# Access Compliance Report Public Rights-of-Way (Curb Ramps)

| ADA ID: RPRK211201140959                | Ramp Type: Type 4 - Parallel | Initial Pass/Fail: Pass | Overall Compliance: No                  | Severity Score: | 0  |

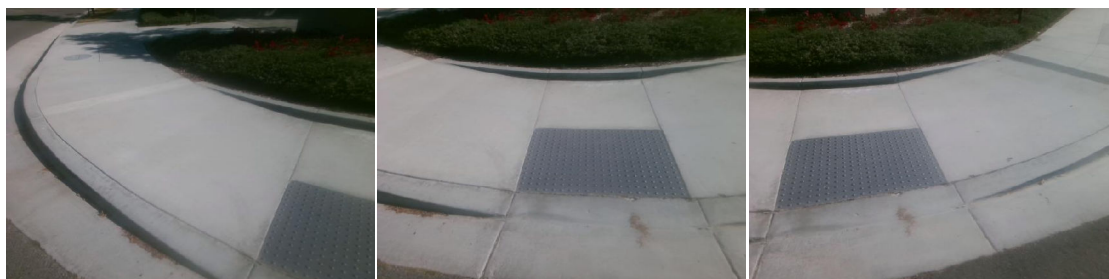
**R304.2.2, STD 1115**

| Compliance | Description                   | Data       | Compliance | Description                   | Data   |
|------------|-------------------------------|------------|------------|-------------------------------|--------|
| Yes        | Gutter Ponding                | No         | No         | Curb Slope                    | 9.3    |

**Remove & Replace Curb Slope.**
